FED. ROAD DIV. NO.	STATE	FED. AID PROJ. NO	SHEET NO.	TOTAL SHEETS
3	MD.		2	5

Revision "B"

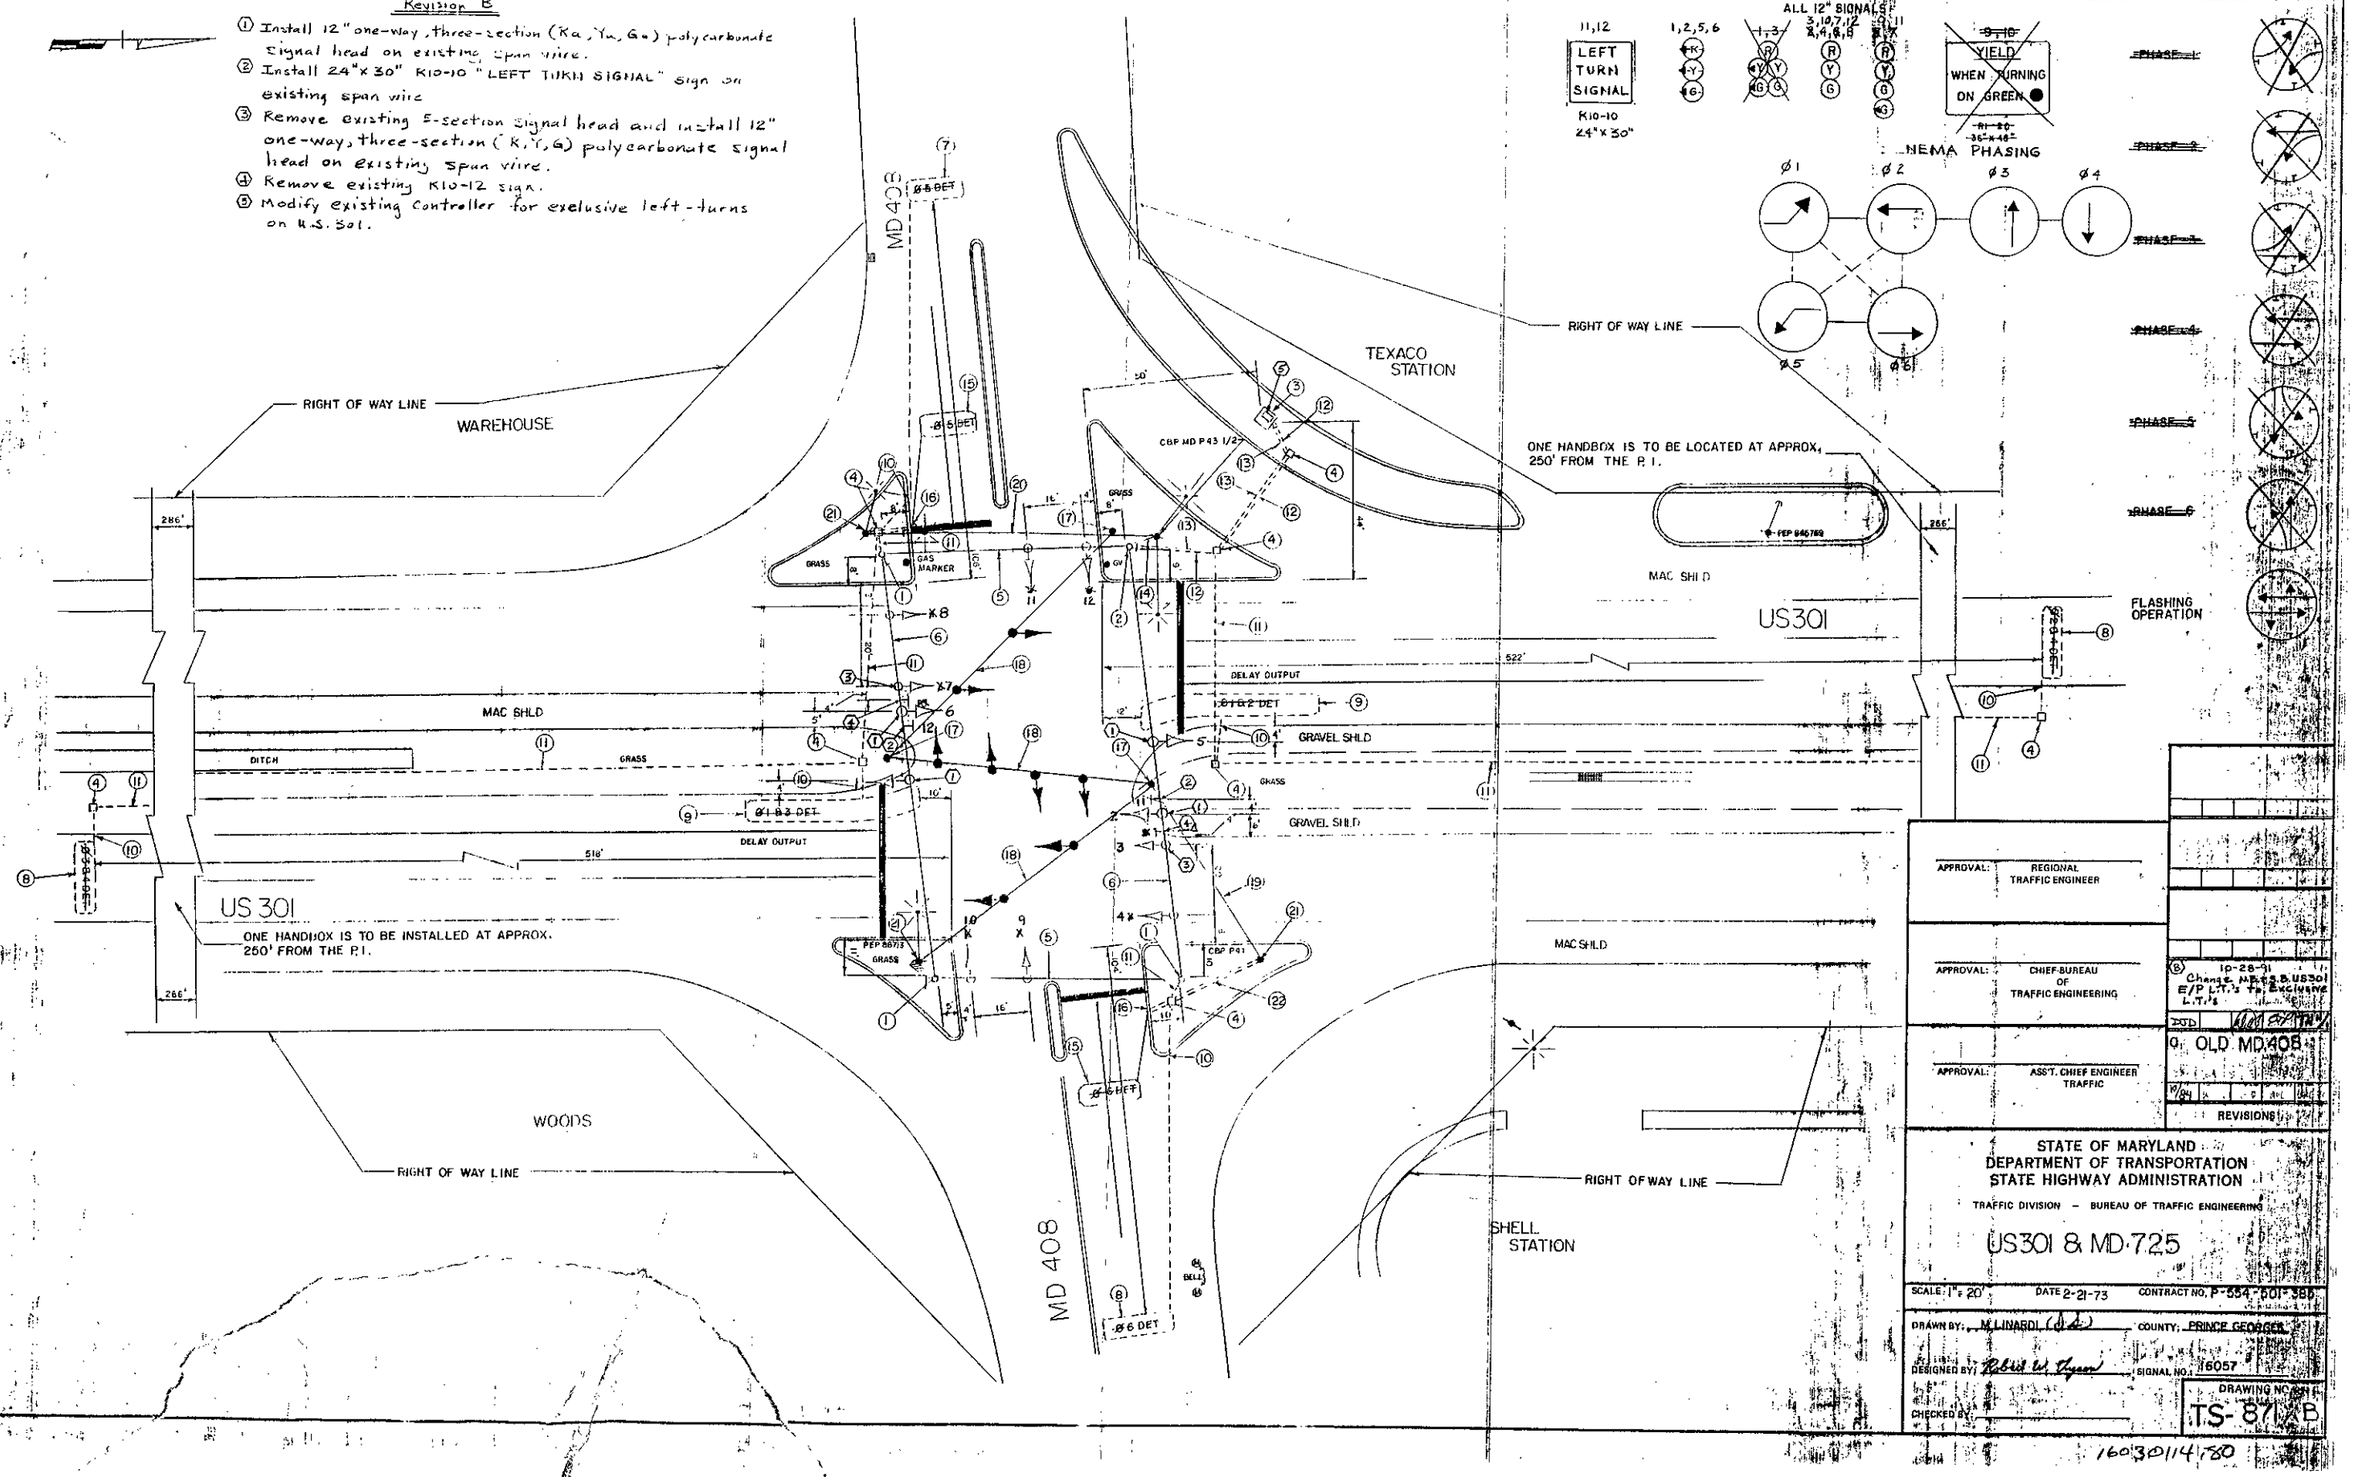
1. Install 12" one-way, three-section (Ra, Ya, Ga) polycarbonate signal head on existing span wire.
2. Install 24"x30" K10-10 "LEFT TURN SIGNAL" sign on existing span wire
3. Remove existing 5-section signal head and install 12" one-way, three-section (R, Y, G) polycarbonate signal head on existing span wire.
4. Remove existing K10-12 sign.
5. Modify existing controller for exclusive left-turns on U.S. 301.
